SERVICE BULLETIN

MODEL BD-700-1A10 (BD-700)

MODIFICATION – DISTRIBUTION – PERMANENT WIRING CONFIGURATION FOR THE FUEL RE-CIRCULATION SYSTEM FOLLOWING POWER SOURCE CHANGE

SERVICE BULLETIN: <u>700-28-039</u>	ISSUE: <u>Basic</u>	DATED: <u>Jul 19/2002</u>
TITLE: Modification – Distribution – Permanent Wiring Configuration for the Fuel Re-Circulation System Following Power Source Change

Wiring Modification
Figure 1

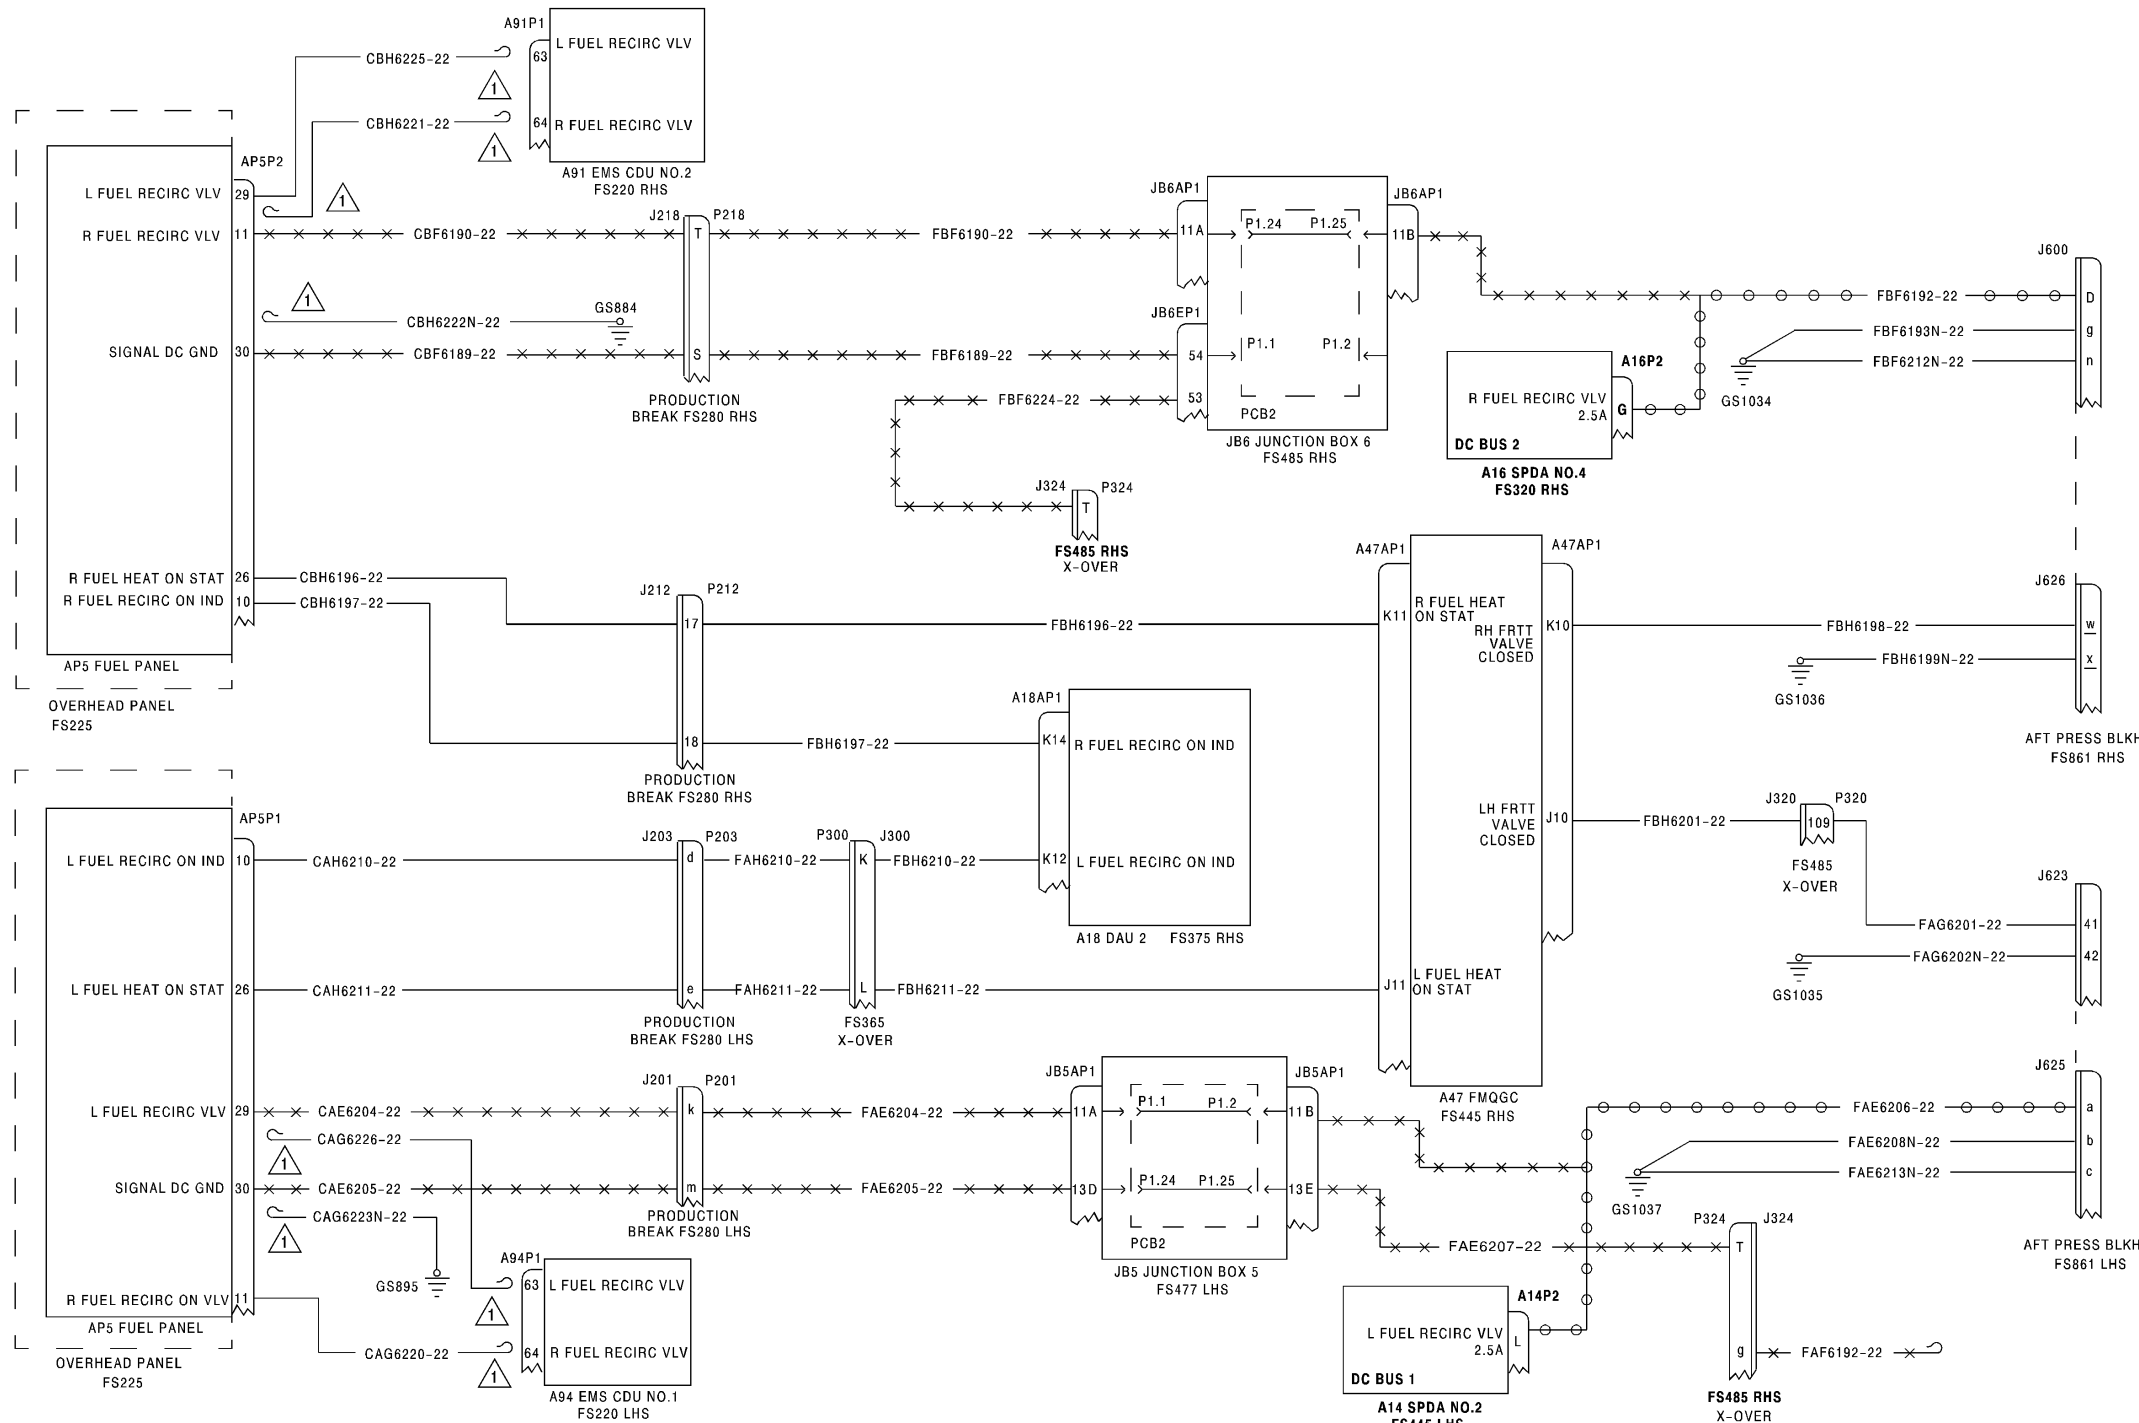
- (1) Do the wiring change given in Figure 1.

WIRE NO.	TO
CBH6225-22	A91P1-63
CBH6221-22	A91P1-64 AND AP5P2-11
CBH6222N-22	AP5P2-30
CAG6223N-22	AP5P1-30
CAG6220-22	AP4P1-64
CAG6226-22	A94P1-63 AND AP5P1-29

WIRE NO.	DISCONNECT FROM	CONNECT TO
FBF6192-22	JB6AP1-11B	A16P2-G
FAE6206-22	JB5AP1-11B	A14P2-L

WIRE NO.	FROM	TO
CBF6190-22	AP5P2-11	J218T
CBF6189-22	AP5P2-30	J218S
FBF6190-22	P218-T	JB6AP1-11A
FBF6189-22	P218-S	JB6EP1-54
FBF6224-22	J324-T	JB6EP1-53
CAE6204-22	AP5P1-29	J201-k
CAE6205-22	AP5P1-30	J201-m
FAE6204-22	P201-k	JB5AP1-11A
FAE6205-22	P201-m	JB5AP1-13D
FAE6207-22	JB5AP1-13E	P324-T
FAF6192-22	P324-g	NOT CONNECTED NEAR SPDA NO.3

⚠ REMOVE CAP AND CONNECT WIRE AS GIVEN IN TABLE 1.
